SERVICE BULLETIN

Garmin SL30 and SL40

Comm Radio Spurious Emissions Correction

SB-LTUL-CT__-04

Fig. 3

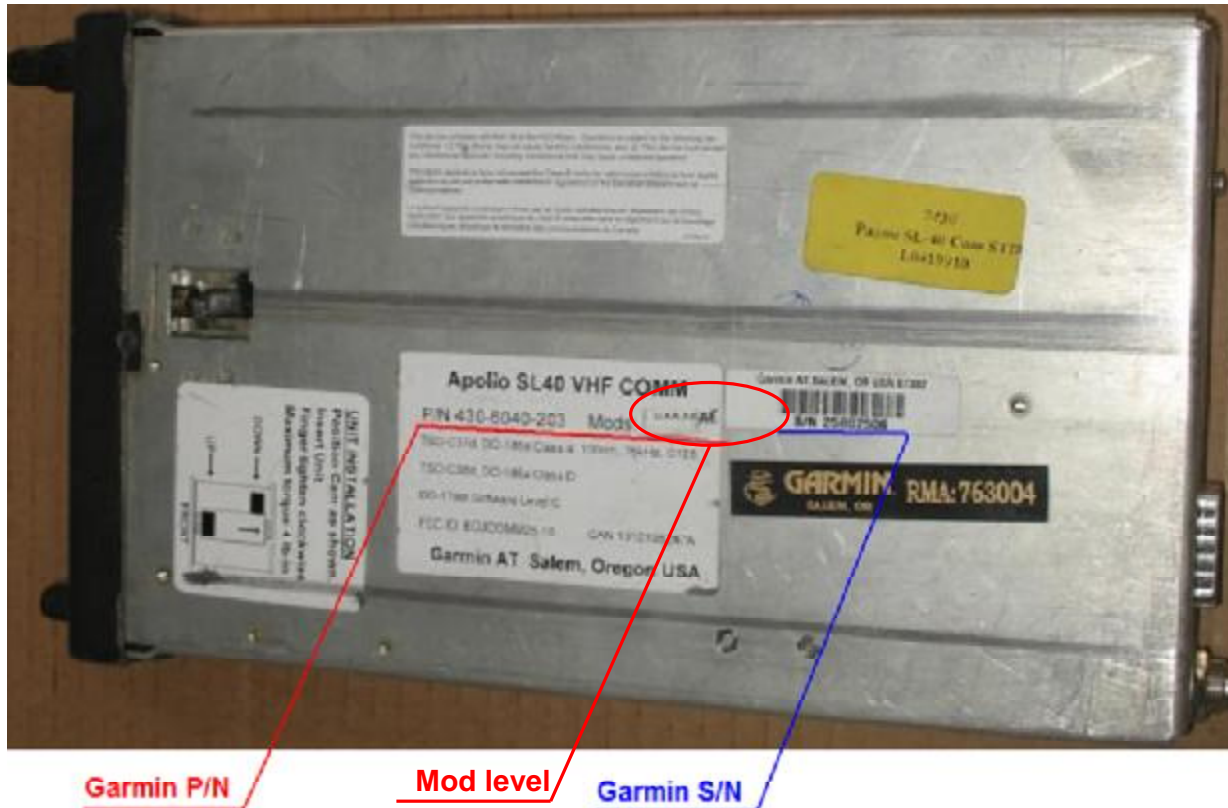
Identify the Mod level from the nameplate on the bottom side of the unit. P/N, Mod level and S/N of the individual unit are shown in Fig. 3.
